Execution PLC-01

1. Controller card standard version

Typedesignation: BM4-O-PLC-01-00-02

Information of nameplate:

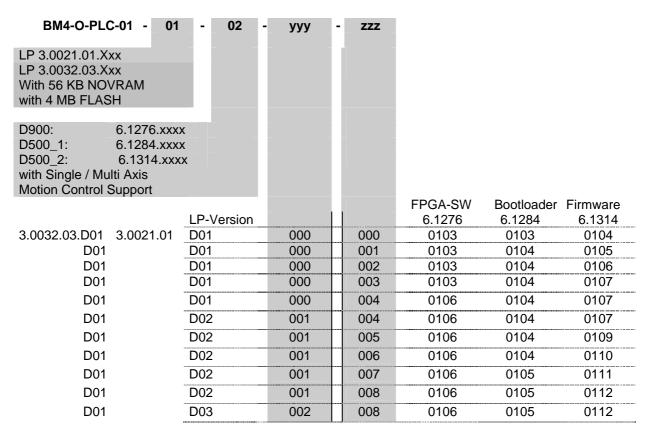
The printed circuit board 3.0021.01.D01 is the first official version.

The printed circuit board 3.0021.03.D01 is the first official version.

The printed circuit board 3.0021.01.D02 is introduced with AT076_05 from March 21, 2005.

Optimized boot behavior (Reset level at the option modules)

The printed circuit board 3.0021.01.D03 is introduced with AT086 07 from March 21, 2007.

Optimized clock signal

Information of nameplate:

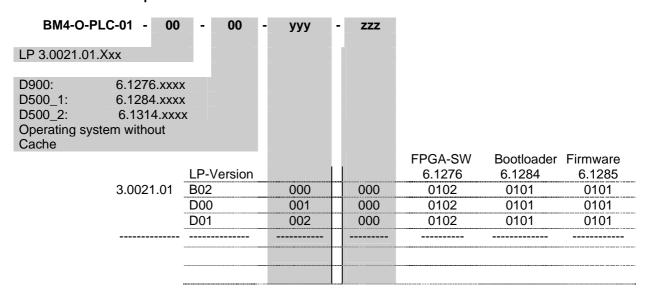
The printed circuit board 3.0021.01.B02 is the first official version.

The printed circuit board 3.0021.01.D00 is introduced with AT161 03 from November 20, 2003.

· Admission of a new layout

The printed circuit board 3.0021.01.D01 is introduced with AT222_03 from October 31, 2003.

New insertion
